LEXINGTON-FAYETTE URBAN COUNTY GOVERNMENT CONTRACT CHANGE ORDER Page 1 of 11		Date:	October 1, 2025
To (Contractor):		Project:	Clays Mill Road Improvements, Section 1
L-M Asphalt Partners, Ltd.		Location:	CMR - Waco to Harrodsburg
dba ATS Construction		Contract No.	17-2020
3009 Atkinson Ave, Suite 400, Lexington, KY 40509		Original Contract Amt.	\$10,683,653.39
		Cumulative Amount of Previous Change Orders	\$1,373,272.58
		Percent Change - Previous Change Orders	12.85%
		Total Contract Amount Prior to this Change Order	\$12,056,925.97
		Change Order No.	5 - Final
You are hereby requested to comply with the following changes from the contract plans and specification;			
Current Change Order

LEXINGTON-FAYETTE URBAN COUNTY GOVERNMENT CHANGE ORDER				DATE:		October 1, 2025
Change Order #:						5 - Final
CONTRACT #:						17-2020
Project: Clays Mill Road Improvements, Section 1						
You are hereby requested to comply with the following changes from the contract plans and specifications;

Clays Mill Road Improvements, Section 1
Change Order No.5 - Final
Reasons for Porposed Changes

1896 -1898 Clays Mill Road

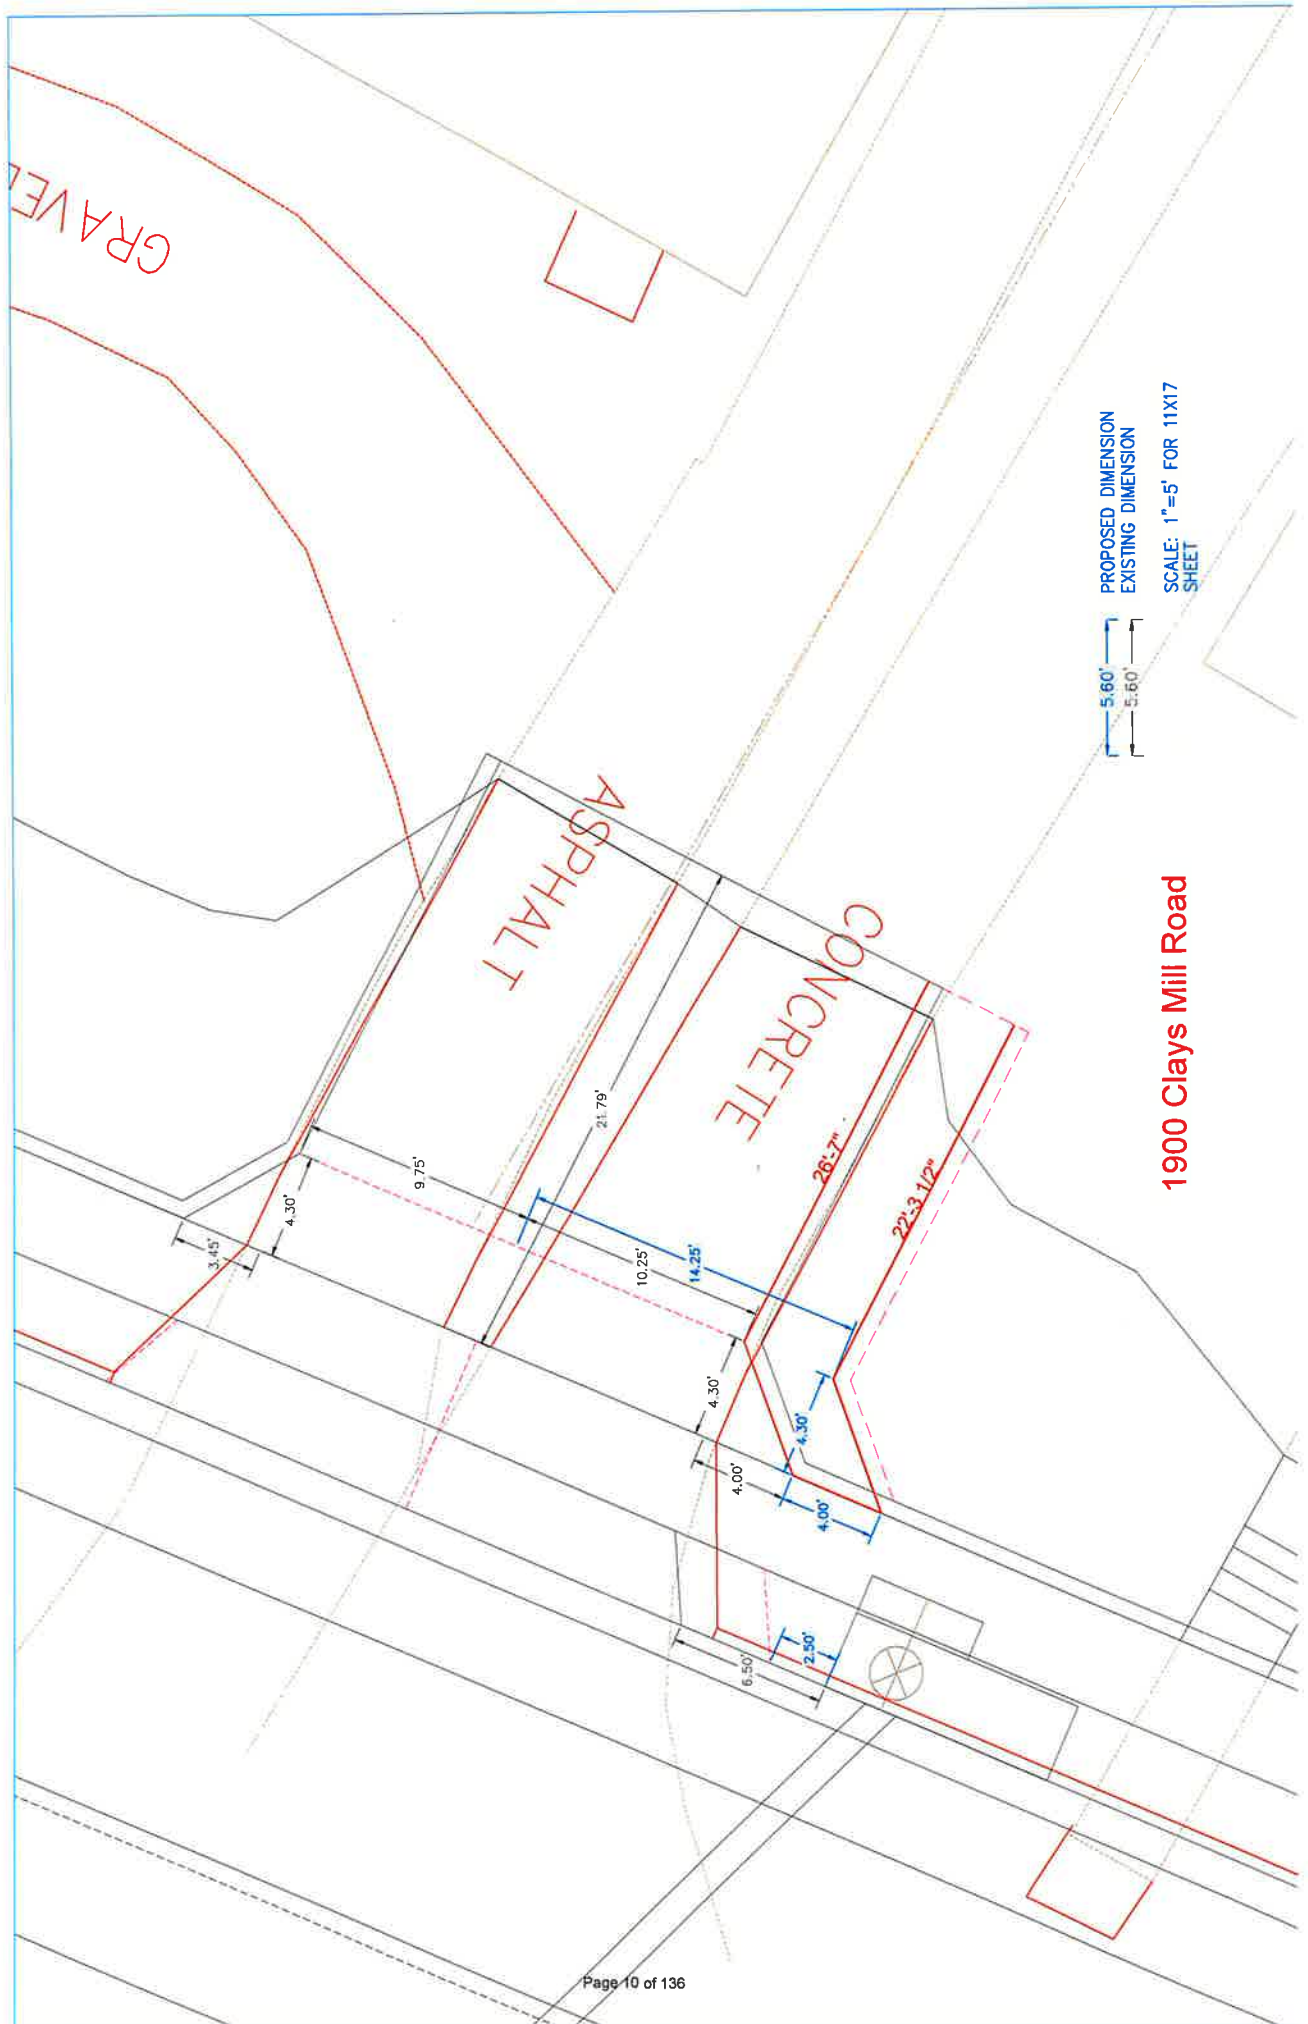
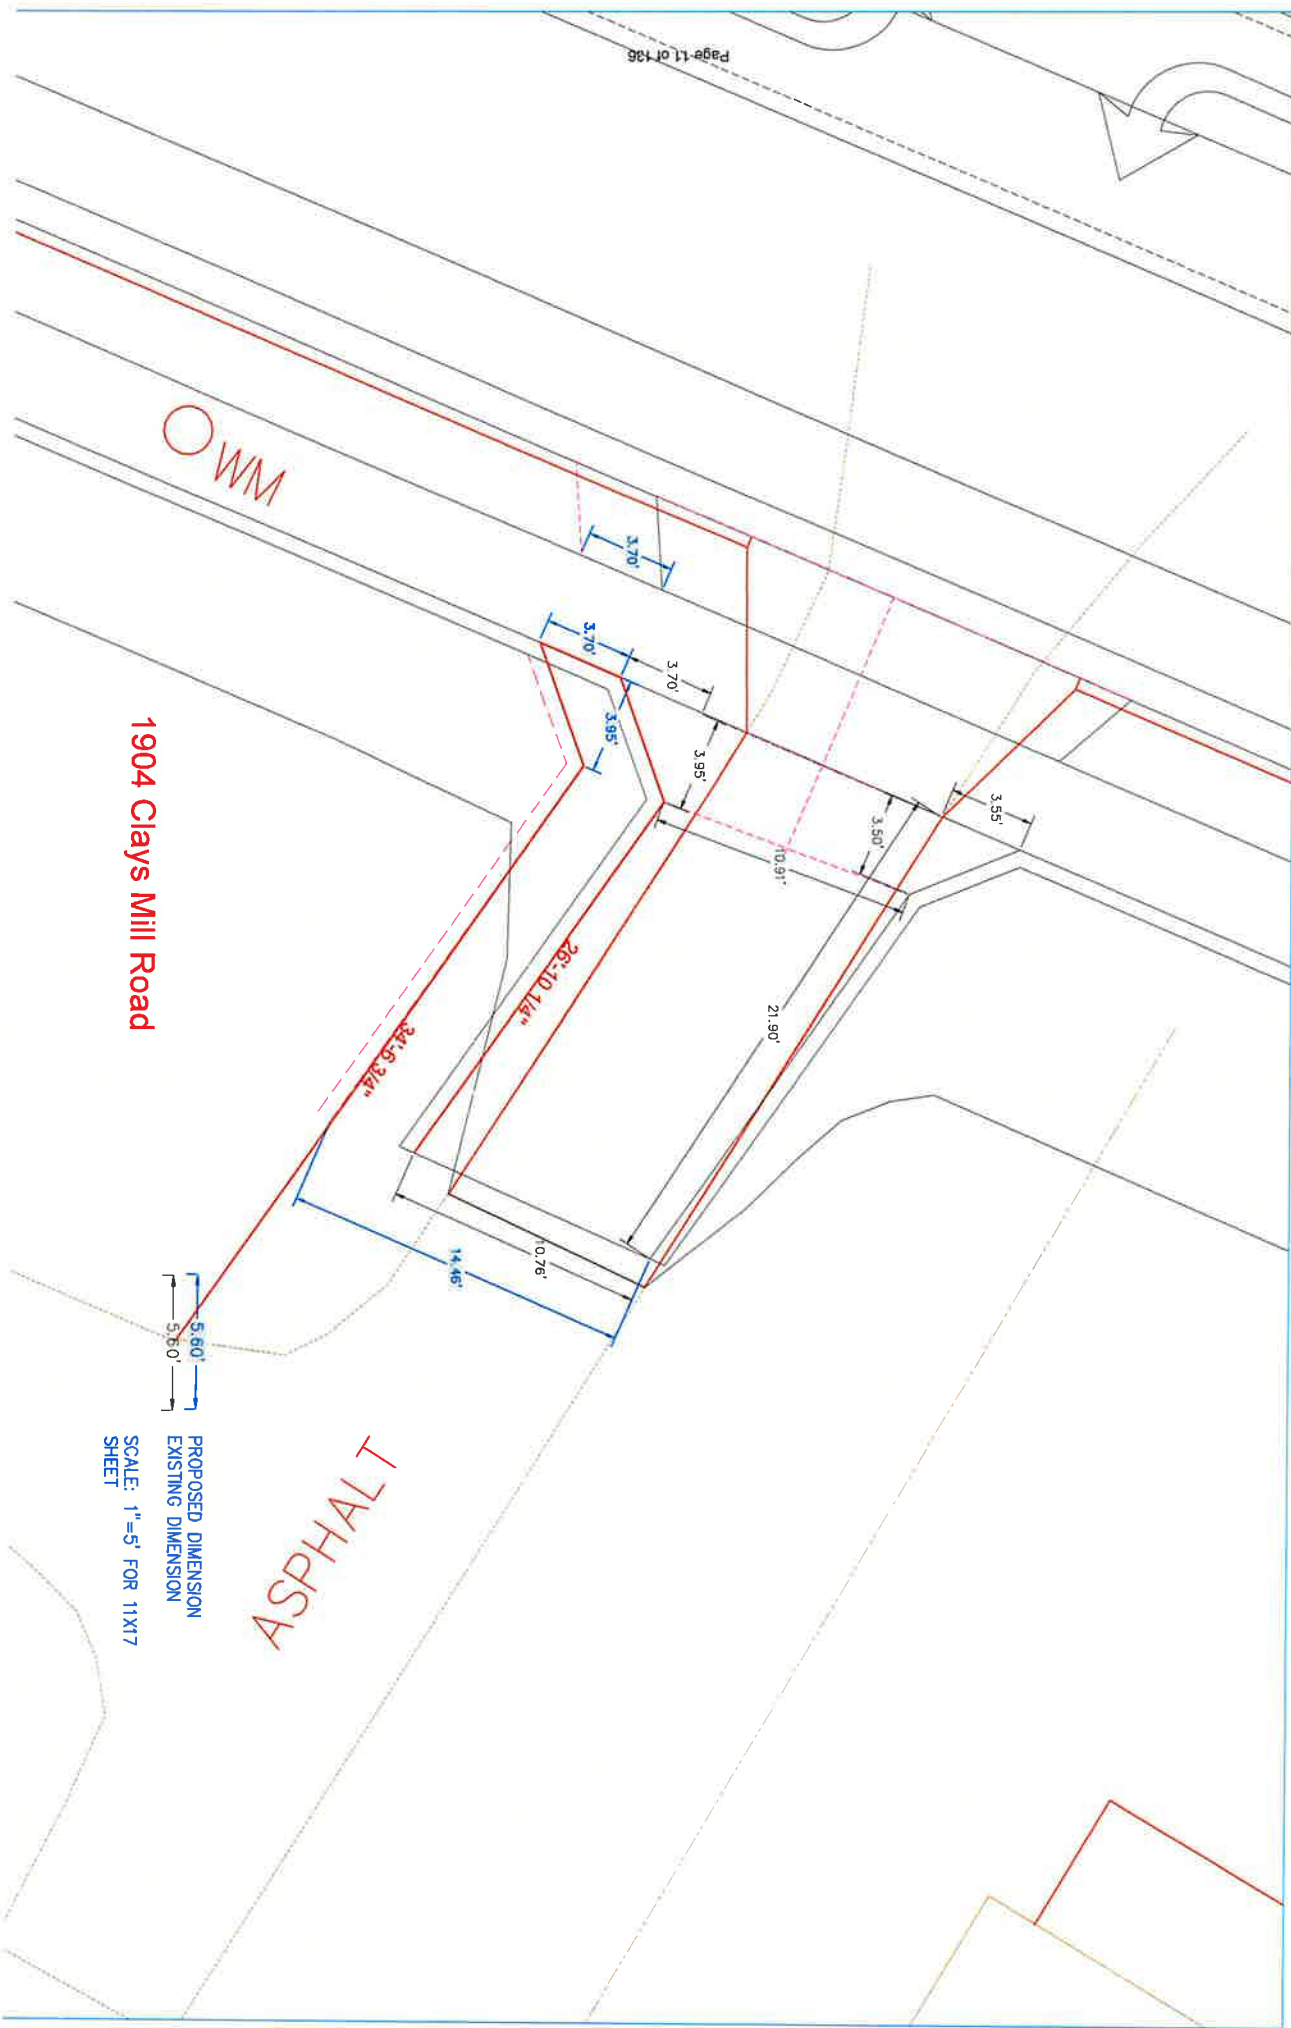
1. Adjustments to retaining walls to provide better clearance for vehicles in and out of four driveways. The walls were originally built to the width of the existing driveways. After constructing, property owners complained that they sometimes rub up against the walls because the width is too narrow.
2. Construction of a surface drain and connection to the storm sewer to prevent standing water in a residential driveway. Clays Mill Road was substantially raised in front of this property, resulting in a low spot in their driveway that hadn't existed before. This drain corrects the problem.
